Staff Report
 PZ21-00014 (SUB)
 Chapel View Terrace
 Summary Sheet

Meeting Date: October 18, 2022
Hearing Body: Planning and Zoning Commission
Project Summary: **6 unit single family house subdivision**
Action Requested: Recommendation of Approval of Preliminary Plat
Staff Recommendation: Recommendation of Approval, with conditions, of Preliminary Plat
Location: 10 Sky Line Drive (Southwest of Chapel Road roundabout)
Parcel Number: 401-34-033B
Owner/Applicant: Passion LLC (Chris Rife)
 6817 S Pinehurst Drive; Gilbert, AZ 85298
Authorized Agent: Sefton Engineering Consultants (Luke Sefton)
 40 Stutz Bearcat Drive; Sedona, AZ 86336
Site Size: ± 3.29 acres
Community Plan Designation: Single Family Low Density
Zoning: RS-18 (Single-Family Residential), maximum density: 2 units per acre
Current Land Use: Vacant
Surrounding Properties:

SHEET TITLE: PRELIMINARY PLAT
PROJECT TITLE: CHAPEL VIEW TERRACE
DRAWN BY: RJB
SCALE: 1" = 30'
DATE: 06/23/2022
PROJECT NO: 210305
SHEET NO: 2 OF 2

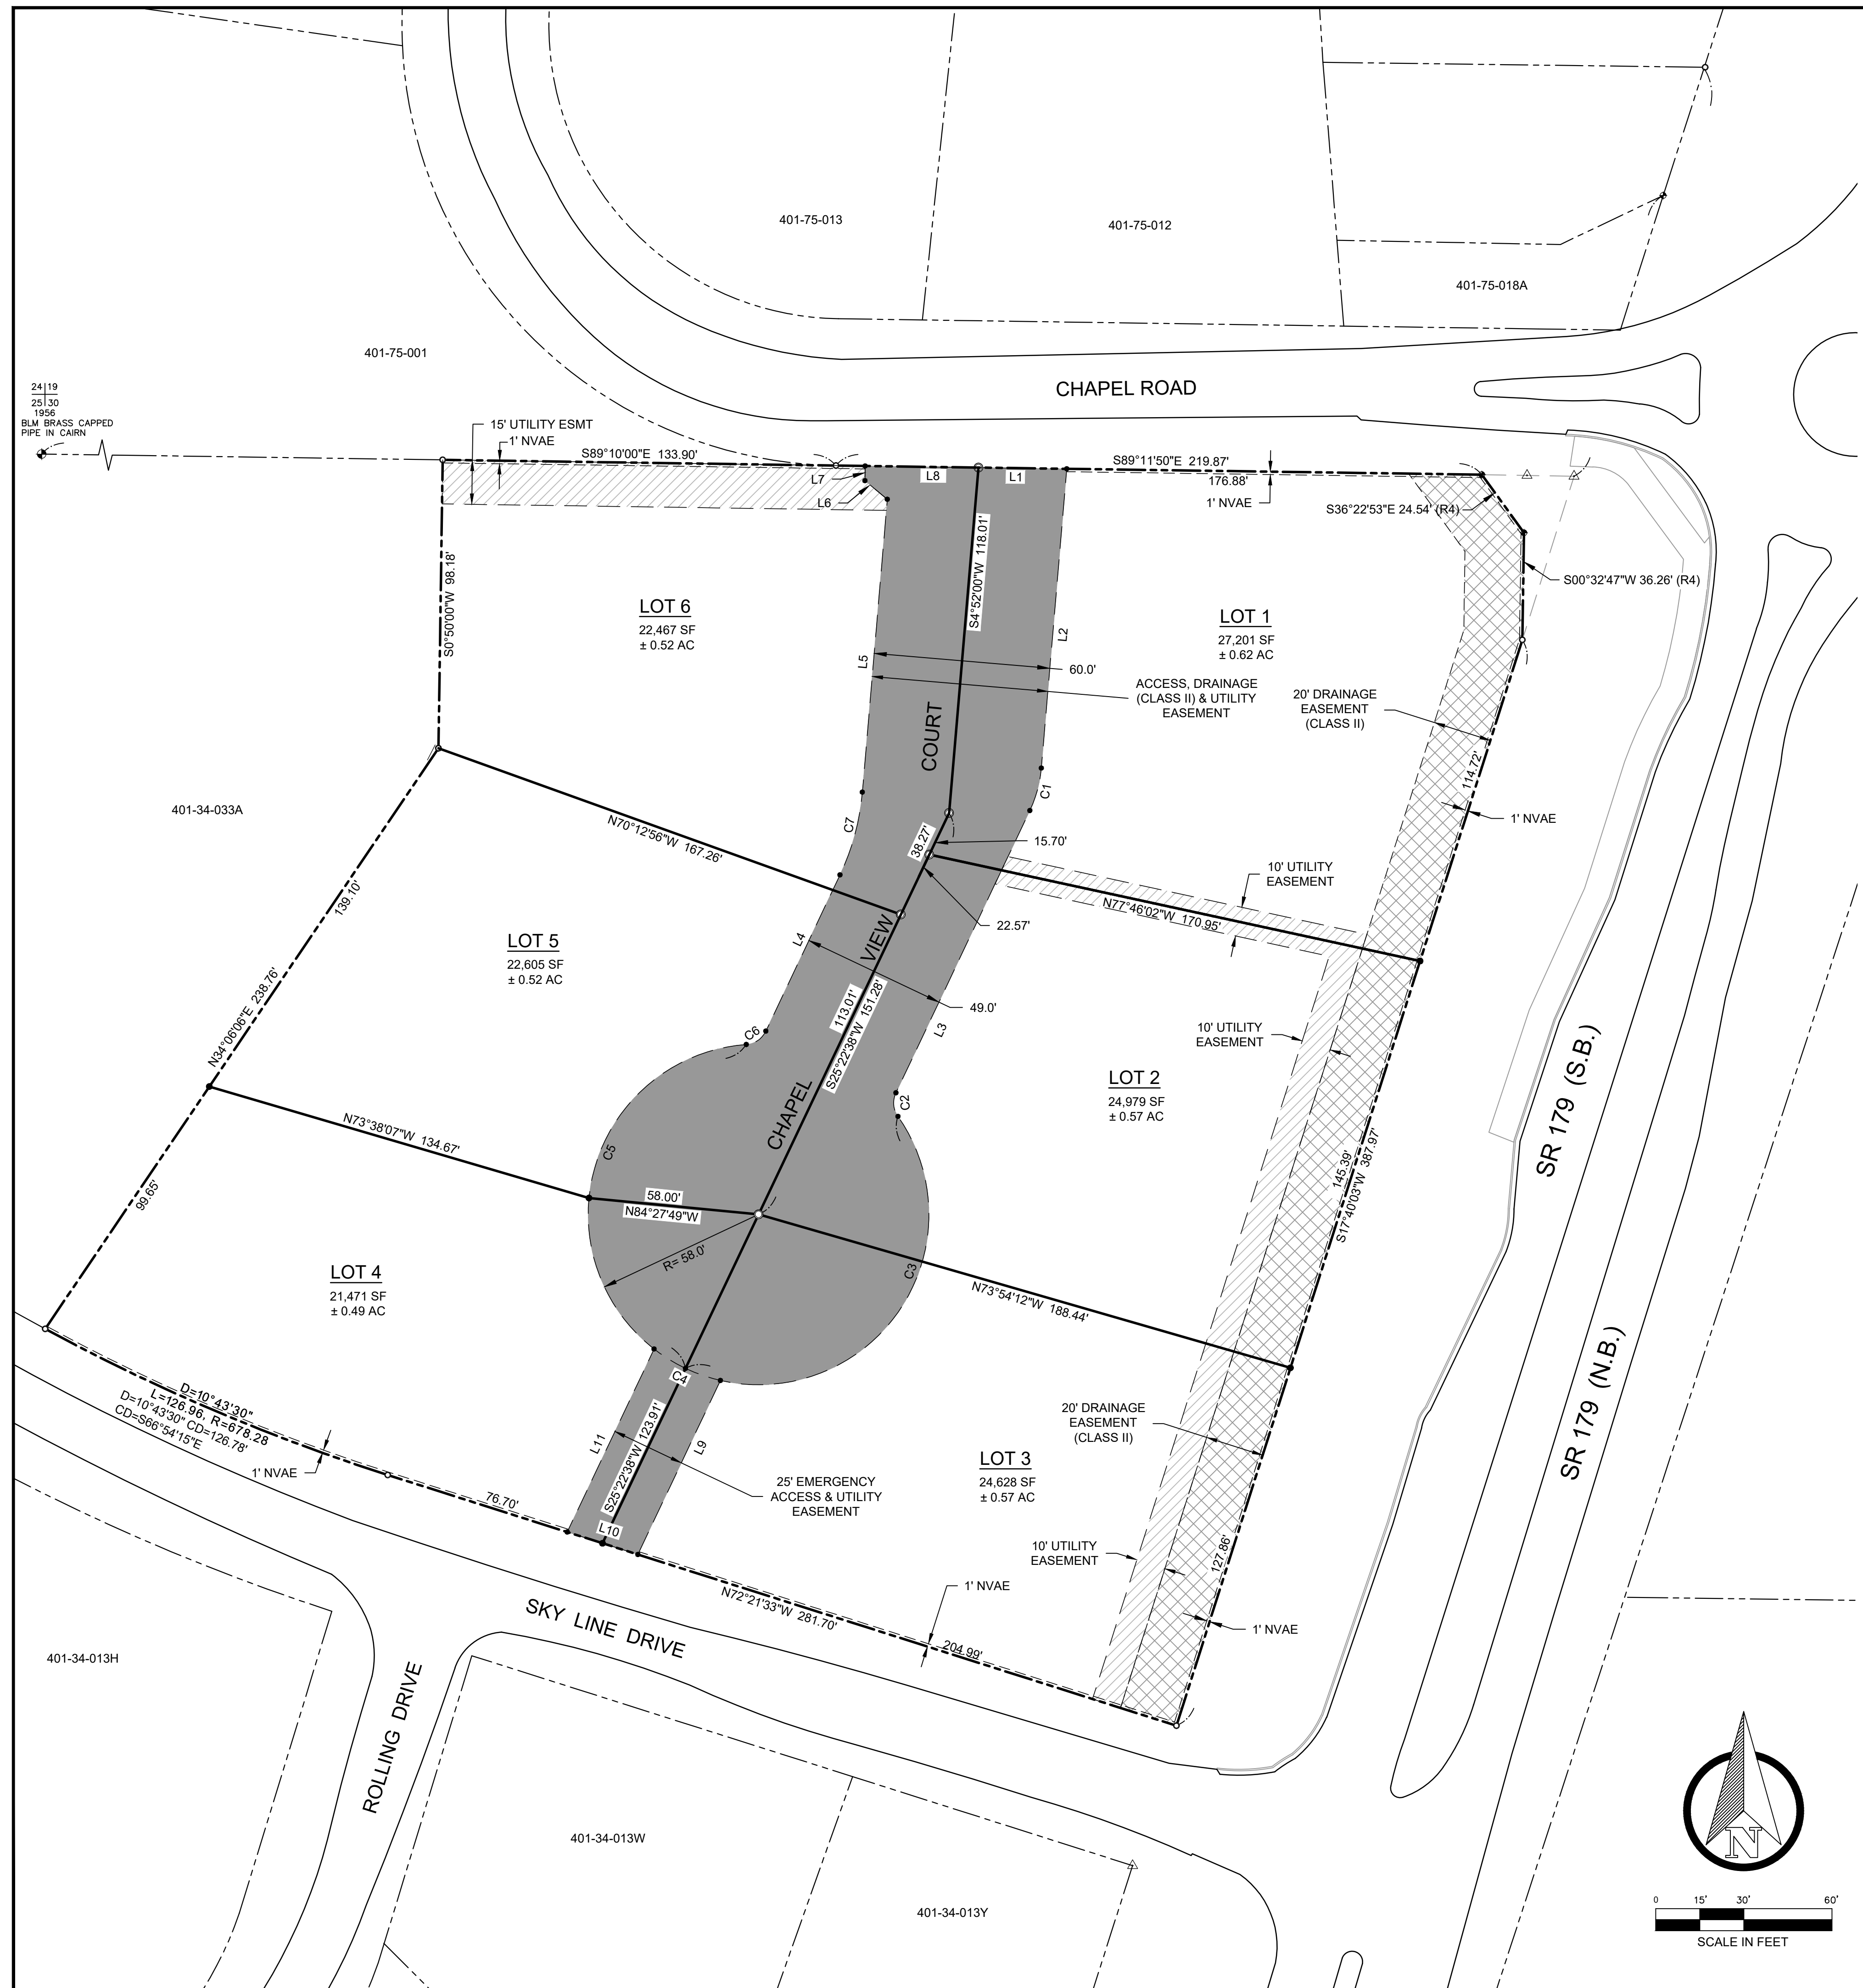
- The proposed subdivision meets the zoning requirements for maximum density, minimum lot size and width, and lot layout.
- The City's Engineering Staff has reviewed the conceptual grading and drainage plans and will review the final plans for compliance with applicable requirements.
- No floodways or floodplains impact the site.

The primary concerns brought up in public comments were from property owners on Chapel Road regarding short term rentals and the construction of sidewalks. As the property is being subdivided under the current zoning, the City cannot regulate short term rentals. Regarding sidewalks, construction of sidewalks is required by the LDC and recommended by the GO! Sedona plan to increase the walkability of the City.

Per discussions with the developer, we understand the City of Sedona is requiring a sidewalk to be constructed on a portion of West Chapel Road as well as in the proposed cul-de-sac. We are opposed to the sidewalks in question, a sentiment we share with the overwhelming majority of our neighbors on West Chapel. We have also made the developer aware of our concerns.

We kindly ask the Planning and Zoning Commission take into consideration the above and not require a sidewalk to be constructed on West Chapel as part of case number is PZ21-00014.

1. Development of the subject property shall be in substantial conformance with the applicant's representations of the project, including the Preliminary Plat dated June 23, 2022, grading and drainage plans, letter of intent dated July 25, 2022, and all other supporting documents, as reviewed, modified and approved by the Planning and Zoning Commission and City Council.

- ix) Provide a striping & signing plan for the subdivision.
 - x) Manholes over 8' in depth (only SS MH3,5,6) shall have a cover of 30" for confined spaces safety. Please annotate the 30" ring & cover on the plans for these manholes. Please include in notes
